WARNING! Make certain you are using the Correct Valves on Caterpillar® 3408 / 3412 Cylinder heads

JUNE . 2002

IPD-TB-0003

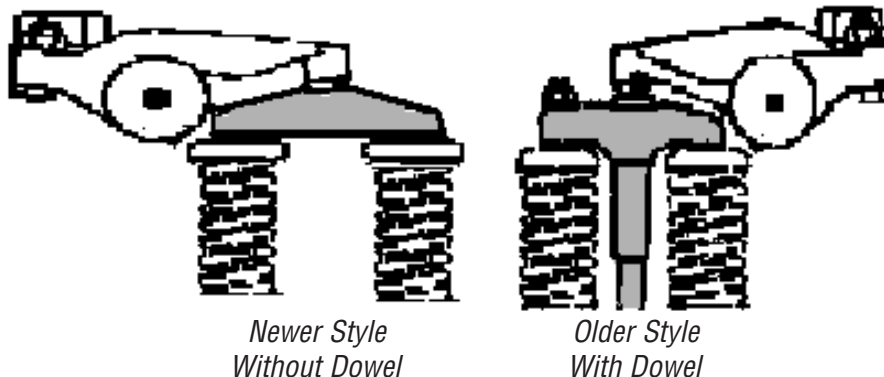
Caterpillar® 3408 & 3412 cylinder heads with valve bridges that do not ride on dowels use a longer intake and exhaust valve than previous models!

Older Caterpillar® 3408 & 3412 engines use a valve bridge that rides on a dowel pressed into the cylinder head. Engines with the serial numbers listed below may utilize a valve bridge that does not ride on dowels; newer engines as well as HEUI engines use longer intake and exhaust valves.

Difference in valve length as follows: (Distance measured from top of keeper groove to top of valve).

Part No.	Description	For use in	length
1220321	Long Exh. Valve	Later engines wo/dowel	15.45mm (.608in)
1220322	Long Int. Valve	Later engines wo/dowel	15.45mm (.608in)
1152367	Short Exh. Valve	Earlier engines with dowel	12.45mm (.490in)
1152368	Short Int. Valve	Earlier engines with dowel	12.45mm (.490in)

Failure to use the proper valve in the proper cylinder head will cause catastrophic failure!
